Process Sheet

Customer : CC-DAR01 Dart Aerospace Ltd. Drawing Name : D412-742-013
 Job Number : 41048
 Estimate Number : 10804
 P.O. Number :
 This Issue : 07/08/2008 S.O. No. :
 Prsht Rev. : NC
 First Issue : / / Type : LANDING GEAR
 Previous Run : 41046
 Part Number : D412742013
 Drawing Number : DSI 9369/ECN08-510 / *RM 08-071*
 Project Number :
 Drawing Revision :
 Material :
 Due Date : 14/08/2008 Qty: 1 Um: Each
 Written By : *W*
 Checked & Approved By :
 Comment :

DESIGN PH	DRAWN BY AJS	DART AEROSPACE USA, INC. PORT HADLOCK, WA	
CHECKED 	APPROVED	DRAWING NO. DSI 9364	REV. C SHEET 1 OF 1
DATE 08.08.06	TITLE BUSHING INSTALLATION		SCALE NTS
A	07.01.16	NEW ISSUE	
B	07.03.20	ADD TOLERANCE TO 1/2" HOLE	
C	08.08.06	ADDED CHG 005 & SUBS TO EFFECTIVITY. TOLERANCE ON 1/2" HOLES WAS +0.006 -0.000

DART SERVICE INSTRUCTION

DETAIL A: D3591-1 BUSHING INSTALLATION LOCATION

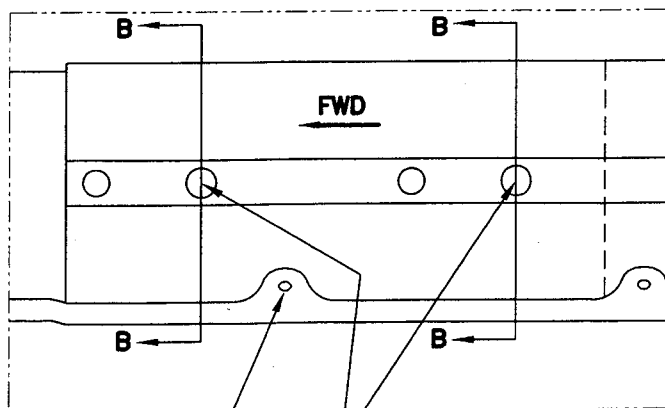
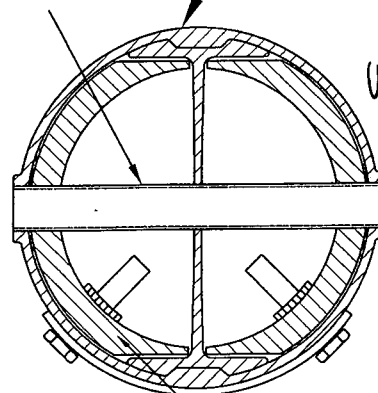
TO PREVENT THE D3391-011/-021 FWD TUBE FROM MOVING WITH RESPECT TO THE D3391-013/-023 MID TUBE, CUSTOMERS RECEIVING D412-742-011/-013 SKIDTUBES AT CHG 002 OR CHG 005 AND SUBSEQUENTS HAVE A D3591-1 BUSHING INSTALLED AT THE FWD SADDLE HOLES AS SHOWN IN DETAIL A (2 PLACES).

CUSTOMERS WITH D412-742-011/-013 SKIDTUBES AT CHG 001, CHG 003 AND CHG 004 CAN PROCURE THE DSI 9364-011 KIT AND INSTALL THE D3591-1 BUSHINGS AS FOLLOWS:

- 1) REMOVE SKIDTUBE/SADDLES FROM AIRCRAFT USING SECTION 32.7 OF ICA-D412-742 AS A GUIDELINE.
- 2) TRANSFER DRILL 1/2" HOLES ($\varnothing 0.500 \pm \begin{smallmatrix} 0.002 \\ 0.000 \end{smallmatrix}$) INTO THE FWD SADDLE HOLES AT THE LOCATIONS SHOWN (2 PLACES) THRU THE D3391-013/-023 MID TUBE AND D3391-011/-021 FWD TUBE. **DO NOT OPEN UP HOLES IN D2571/D2572 FWD SADDLES.**
- 3) REMOVE FWD TUBE FROM MID TUBE, DEBURR DRILLED HOLES, TOUCH UP HOLES WITH MIL-P-85582 OR MIL-P-23377 PRIMER
- 4) RE-INSTALL D3391-011/-021 FWD TUBE INTO D3391-013/-023 MID TUBE USING SECTION 32.7 OF ICA-D412-742 AS A GUIDELINE EXCEPT INSTALL D3591-1 BUSHINGS AS SHOWN IN DETAIL A USING LPS LABORATORIES LPS-3 CORROSION INHIBITOR PRIOR TO INSTALLING THE D2571/D2572 SADDLES.

OPEN TO $\varnothing 0.500 \pm \begin{smallmatrix} 0.006 \\ 0.000 \end{smallmatrix}$ AND INSTALL D3591-1 BUSHING (2 PLACES)

DETAIL A: D3591-1 BUSHING INSTALLATION LOCATION

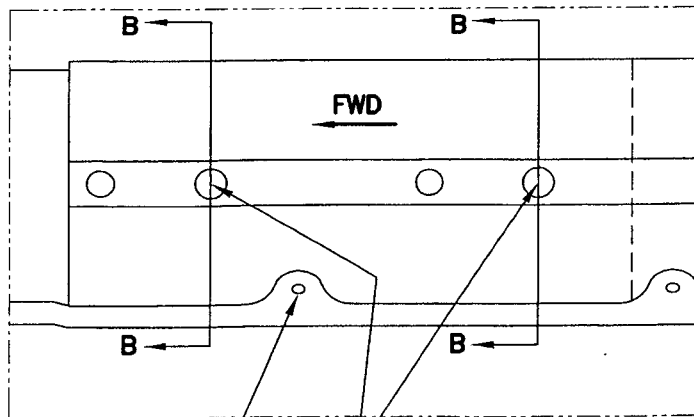
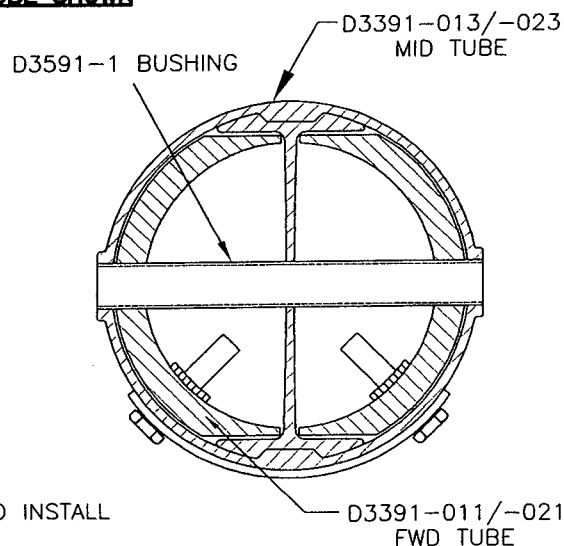
TO PREVENT THE D3391-011/-021 FWD TUBE FROM MOVING WITH RESPECT TO THE D3391-013/-023 MID TUBE, CUSTOMERS RECEIVING D412-742-011/-013 SKIDTUBES AT CHG 002 OR CHG 005 AND SUBSEQUENTS HAVE A D3591-1 BUSHING INSTALLED AT THE FWD SADDLE HOLES AS SHOWN IN DETAIL A (2 PLACES).

CUSTOMERS WITH D412-742-011/-013 SKIDTUBES AT CHG 001, CHG 003 AND CHG 004 CAN PROCURE THE DSI 9364-011 KIT AND INSTALL THE D3591-1 BUSHINGS AS FOLLOWS:

- 1) REMOVE SKIDTUBE/SADDLES FROM AIRCRAFT USING SECTION 32.7 OF ICA-D412-742 AS A GUIDELINE.
- 2) TRANSFER DRILL 1/2" HOLES ($\varnothing 0.500 \pm_{0.000}^{0.006}$) INTO THE FWD SADDLE HOLES AT THE LOCATIONS SHOWN (2 PLACES) THRU THE D3391-013/-023 MID TUBE AND D3391-011/-021 FWD TUBE. **DO NOT OPEN UP HOLES IN D2571/D2572 FWD SADDLES.**
- 3) REMOVE FWD TUBE FROM MID TUBE, DEBURR DRILLED HOLES, TOUCH UP HOLES WITH MIL-P-85582 OR MIL-P-23377 PRIMER
- 4) RE-INSTALL D3391-011/-021 FWD TUBE INTO D3391-013/-023 MID TUBE USING SECTION 32.7 OF ICA-D412-742 AS A GUIDELINE EXCEPT INSTALL D3591-1 BUSHINGS AS SHOWN IN DETAIL A USING LPS LABORATORIES LPS-3 CORROSION INHIBITOR PRIOR TO INSTALLING THE D2571/D2572 SADDLES.

OPEN TO $\varnothing 0.500 \pm_{0.000}^{0.006}$ AND INSTALL D3591-1 BUSHING (2 PLACES)
